# Coastal Access – Hunstanton to Sutton Bridge lengths HSB1, HSB3 and HSB4

## Representations with Natural England’s comments

**September 2021**

**B. RSPB MCA/HSB1/R/5/HSB0673 - Map of plover habitat and distribution from discussion between Natural England's Responsible Officer and RSPB's Sites Manager North West Norfolk reserves**

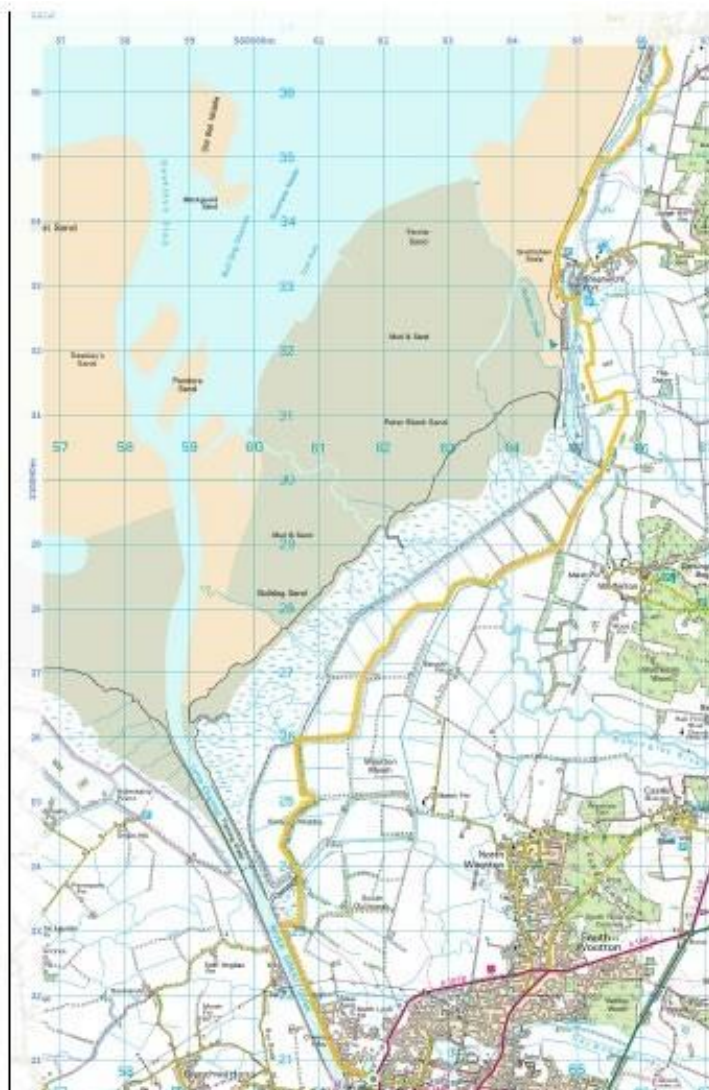
The area seaward and landward of the proposed coast path from HSB-1-SO31 to HSB-1-SO42 FP where there are areas of sand, vegetated shingle, and marshes.

The RSPB is particularly concerned for ringed plover that breed along this stretch of coast, which is an iconic species of the Norfolk Coast Area of Outstanding Natural Beauty (AONB) and listed on Appendix II of the Bern Convention as a Species requiring special protection.

Between 1984 and 2005, the number of ringed plover breeding in Norfolk declined by 63%, with a national decline of 47% between 1984 and 2007<sup>2</sup>. Subsequent coordinated counts since 2014<sup>3</sup> have raised further concerns that the decline has continued. Norfolk currently supports c.2.8% of the UK population of breeding ringed plover and the number of pairs breeding at Snettisham and Heacham make up c.12% of the Norfolk breeding population (*see Supporting Document 5d below*). The numbers breeding along this stretch of coast have declined over time and coincides with increased pressure from visitors to these locations. Liley & Sutherland (2007)<sup>4</sup> modelled change in ringed plover numbers based on changes in disturbance levels and determined the degree to which disturbance can depress the population. Of significant concern is the current population level is significantly lower than any of the model predictions. This is of serious concern for this well-studied ringed plover population. The proposed coastal access route offers an opportunity to implement appropriate management along this stretch of coast to better manage visitor disturbance, however, the RSPB is concerned that too much onus is being placed on signage alone to address problems. Monitoring proposals are limited and are unlikely to provide any meaningful data. The RSPB therefore considers the **proposals to manage impacts on this species are inadequate as currently set out.**

**HSB-1-S034 to HSB-1-S039**; alignment away from the beach, on a route that is up to 400m inland. This is, in part a response to potential ringed plover nesting habitat on the beach.

**HSB-1-S040** is an existing walked route landward of the beach. HSB-1-S040 to HSB-1-S042 are within the Snettisham Coastal Park that offers free and open access to 47 hectares (115 acres) of beach, grass, dunes and scrub.

**HSB-1-S041** is mainly on a hard-surfaced flood defence bank and so is likely to be the preferred walking surface compared to the soft sand on the beach.

**HSB-1-S042** is on a public footpath up to 50m landward of the sandy beach. The car park landward of HSB-1-S042 has 300 spaces and serves the visitors to Snettisham Beach and the Coastal Park. There are over 400 caravans on nearby sites. This area currently has a high recreational use, with residential and day visitors likely to spend time on the beach.

H Local Access Forum [MCA/HSB3/R/3/HSB0799](#) – Photographs from representation

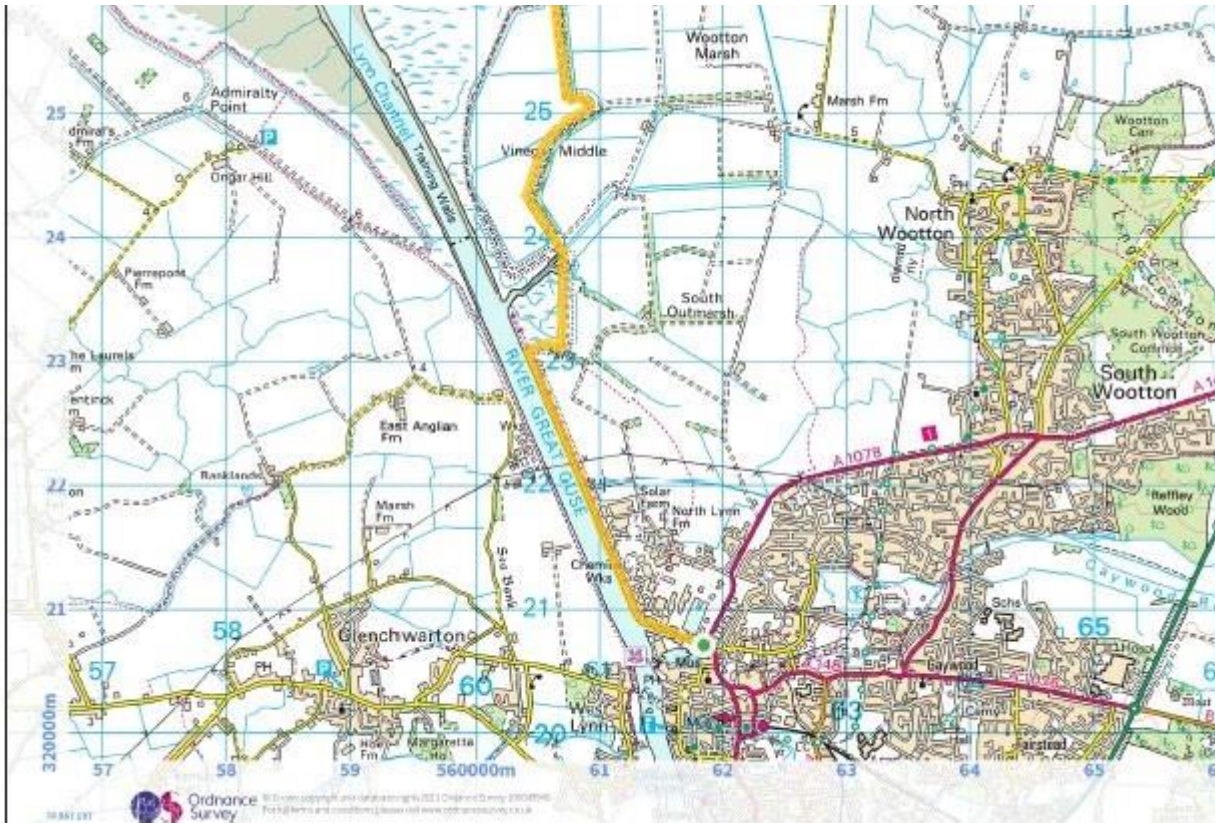
Top: BOAT running alongside the river. Also shows a loop (grey surface) that has been put in so the turbine blades do not oversail the BOAT.

Bottom: BOAT and base of turbine alongside the river

- d. We investigated the complicated planning history of the wind turbine on BOAT 1 and looked at Norfolk County Council's Rights of Way response to the Cross Bank Road turbine planning proposal. The response recommended that the minimum separation to the BOAT should be topple distance, but unfortunately this could not be implemented due to site constraints.

Taking on board all these factors Natural England decided that whilst BOAT 1 offered a more direct and therefore convenient route, it was potentially unsafe, as recognised by government planning guidance and would not be a pleasant alignment option for walkers.
